ARCHITECTURE REVIEW - MARKABLE ISSUES

Project Title:-
Residence for Mr. Thomas
15 Oak St, Boston

Ground Floor
Layout

AA101

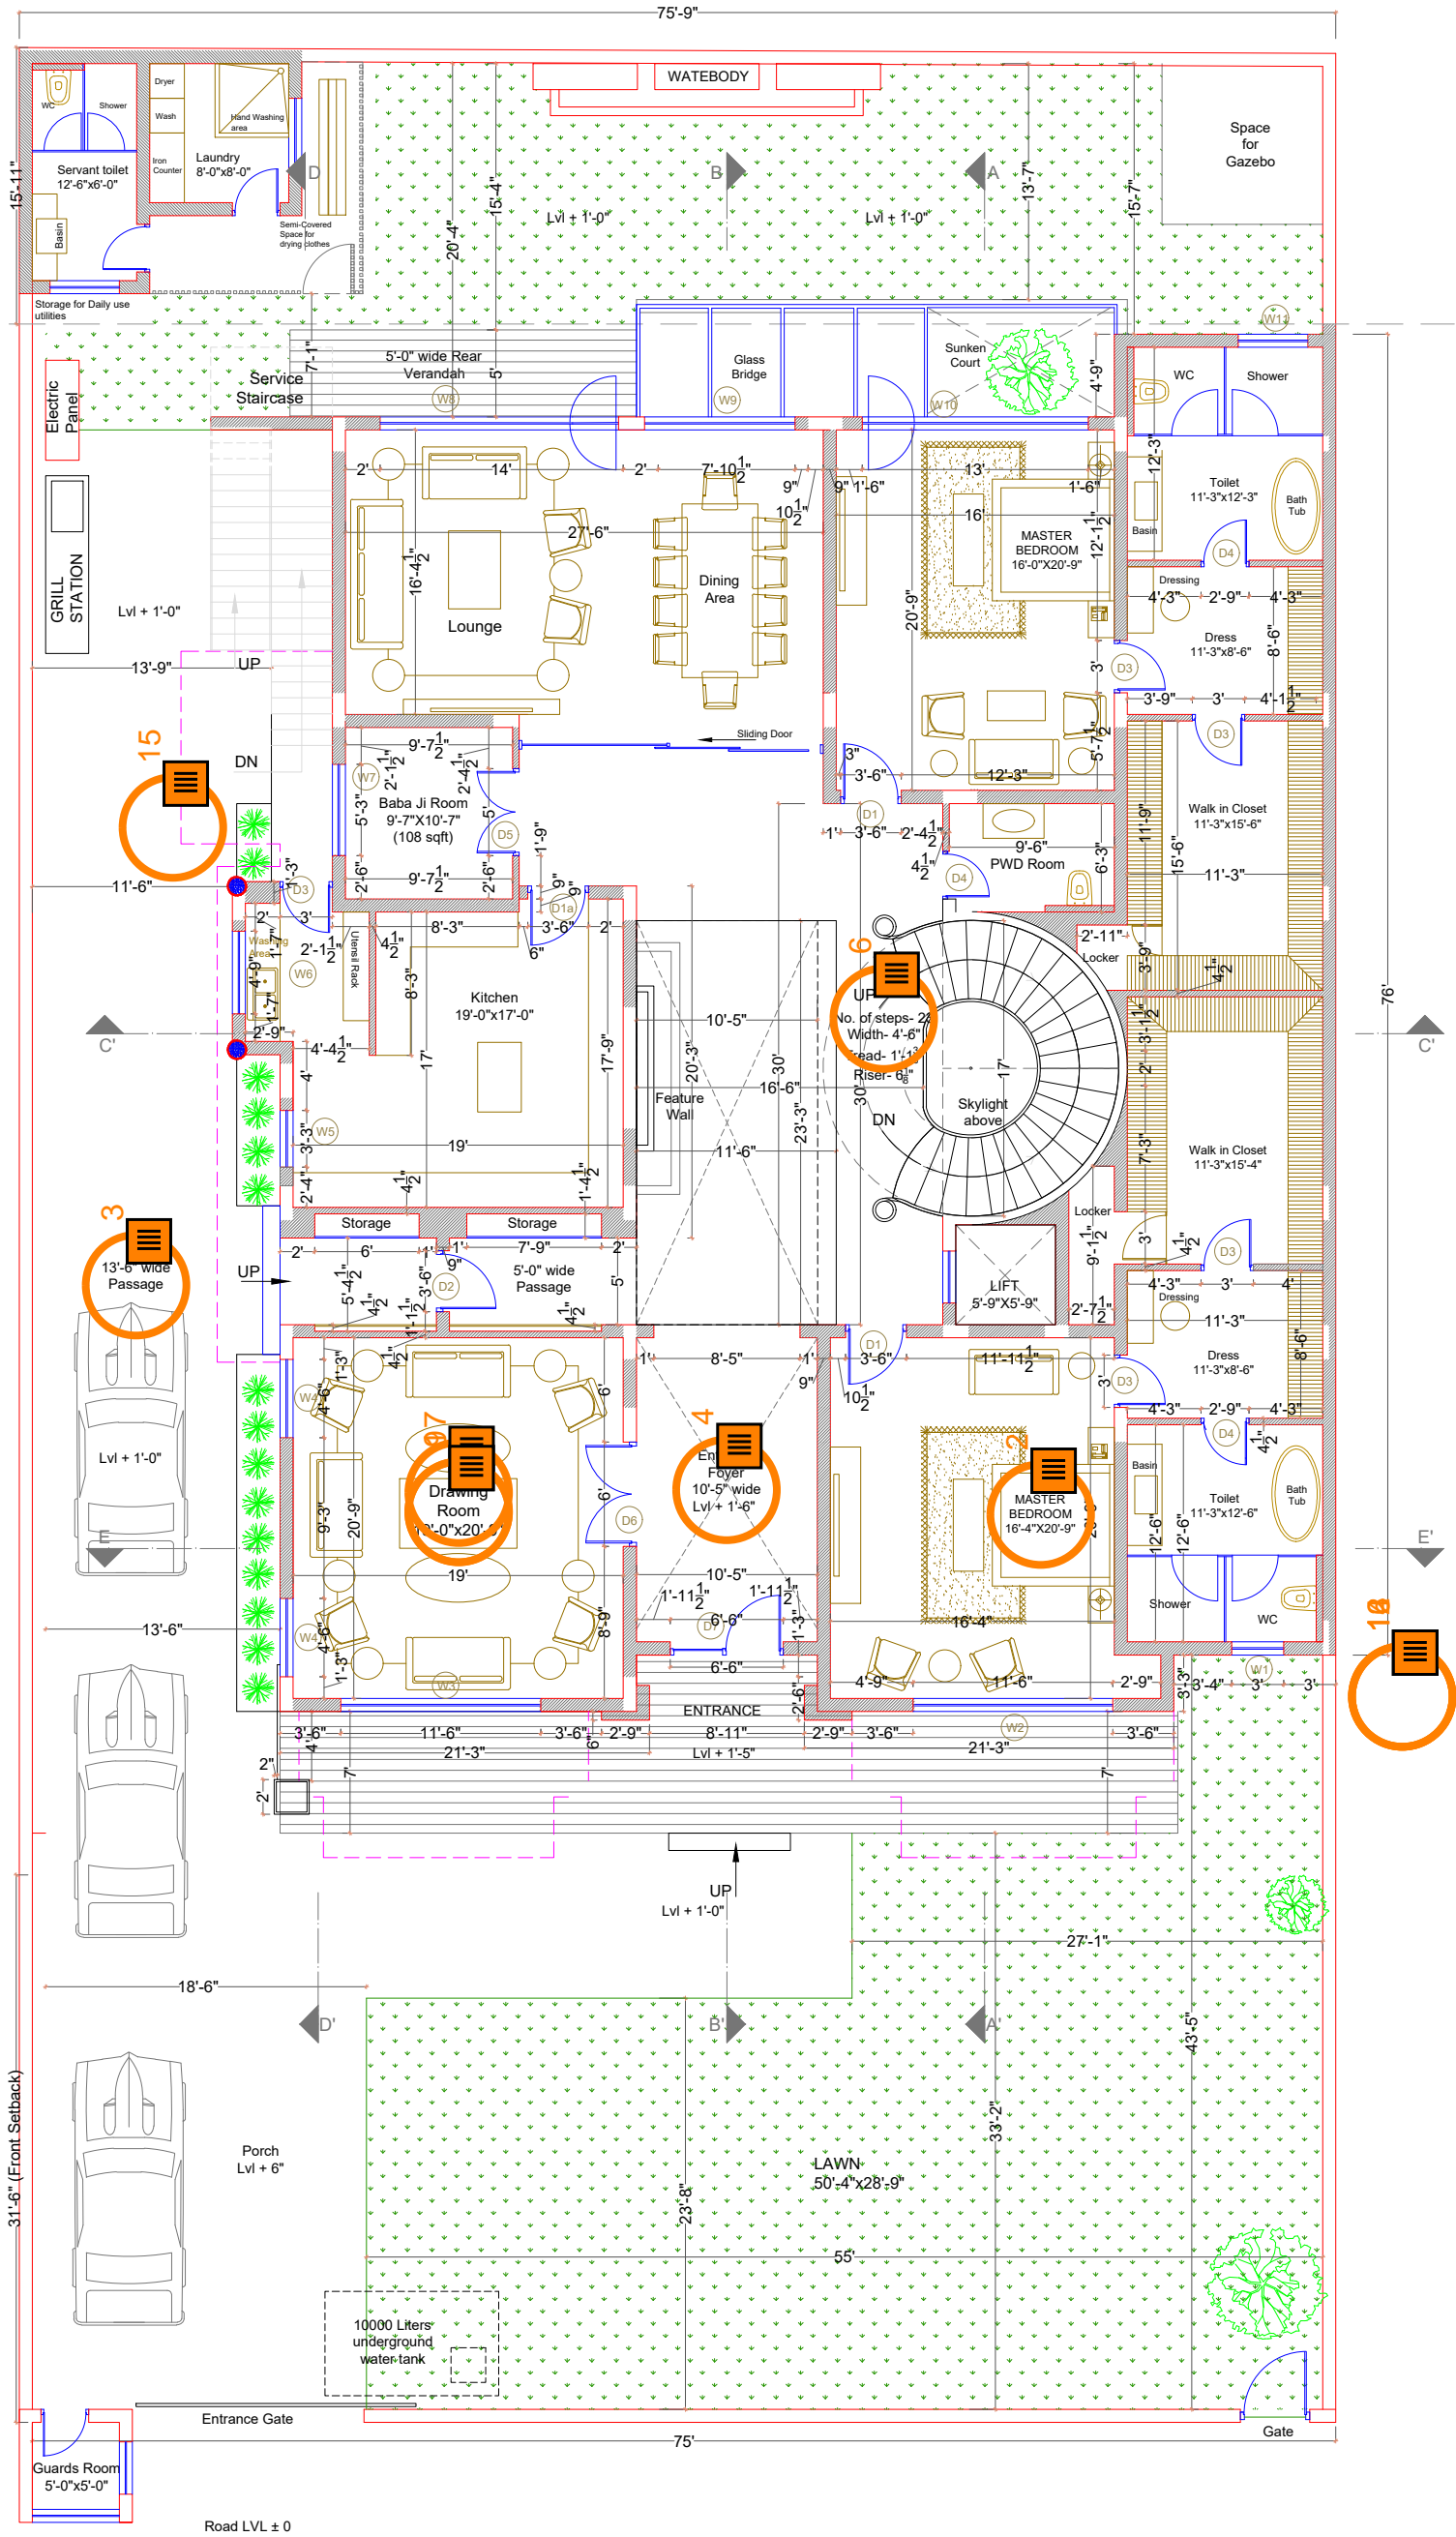
Bedroom dimensions potentially not meeting minimum standards.

Bathroom/toilet sizing and layout may not be optimal for functionality.

Corridor width seems narrow for functional requirements.

Door swing into narrow corridor could obstruct movement.

Text and dimensions overlap, affecting readability.

Staircase rise/run does not appear reasonable.

North arrow missing, affects orientation understanding.

Handrail positions and design potentially incorrect for safety.

Room labels overlap furniture and walls.

Staircase location may impact overall circulation.

Bathroom/toilet layout may not be optimal

Corridor width seems narrow

Staircase location may impact circulation

Door swing obstructs corridor

Staircase rise/run not reasonable

North arrow missing

Handrail positions potentially incorrect

Review and confirm compliance with NBC recommendations for minimum room sizes.

Verify compliance with space and accessibility guidelines.

Ensure corridors meet minimum width requirements for safe passage.

Change door swing direction or adjust position to prevent obstruction.

Adjust text placement to avoid overlap and improve clarity.

Reevaluate stair dimensions to conform to ergonomic standards.

Add a north arrow to all drawings for clarity.

Review and ensure handrails meet safety requirements.

Adjust placement of room labels for clarity.

Review staircase location in relation to main circulation paths and adjust as needed.
